FCON_2, improving the 10MHz and IRIGB Signals

IRIGB, provided by the WR-LEN

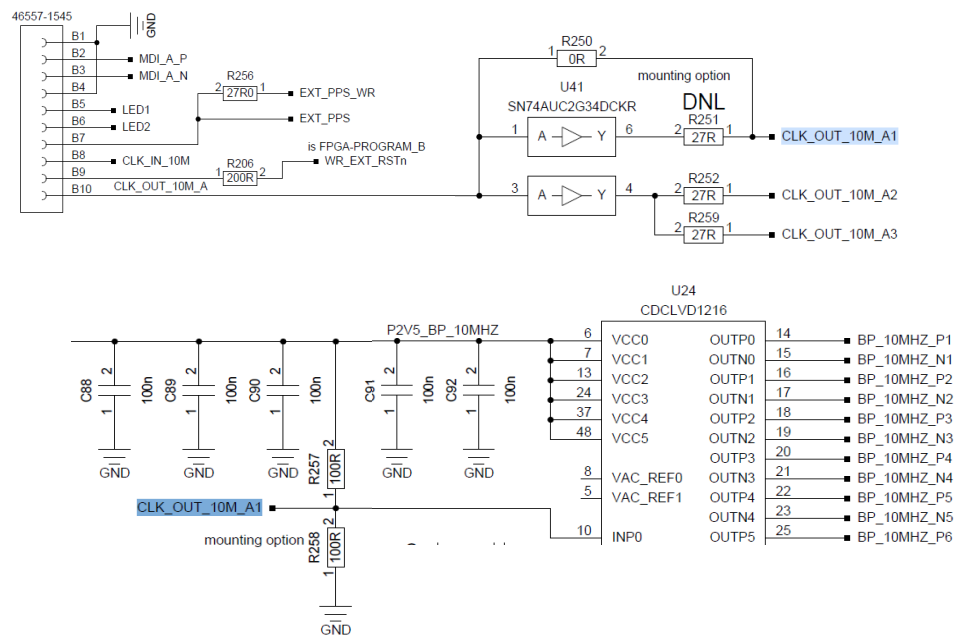
To improve the signal shape at the IRIGB-fanout U26 and to get rid off reflections, C102 has to be removed. To be considered is the influence of the signal termination at the SMA connector J16 on the signal high-level at the fanout driver U44. A minimum high-level of 1.7V is required.

IRIGB at SMA with 50ohm load and 2.5V-fanout-driver-input, measured at **FCON_1**. High level of 1.8V is achieved here, should be the same for FCON_2.

10MHZ, provided by the WR-LEN

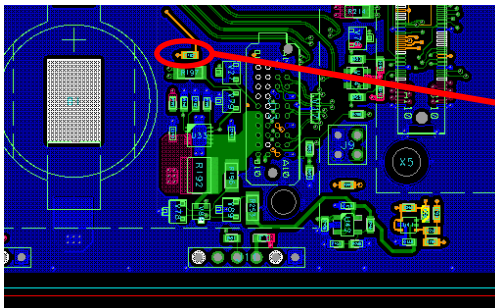
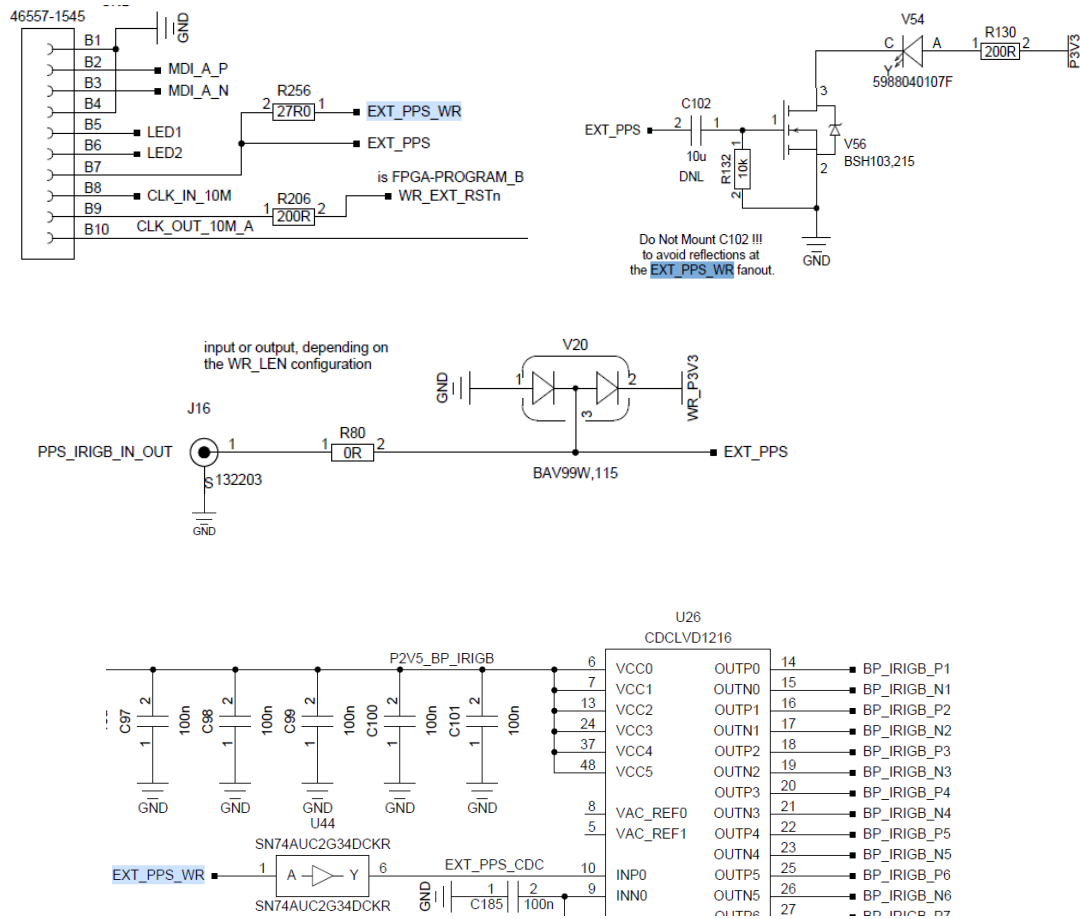
To improve the signal shape at the 10MHZ-fanout U24 and to get rid off the buffer U41 chip to chip skew. See below the 10MHz from WR-LEN to U24.

1. Remove R251, mount R250 = 0R / 0603 instead
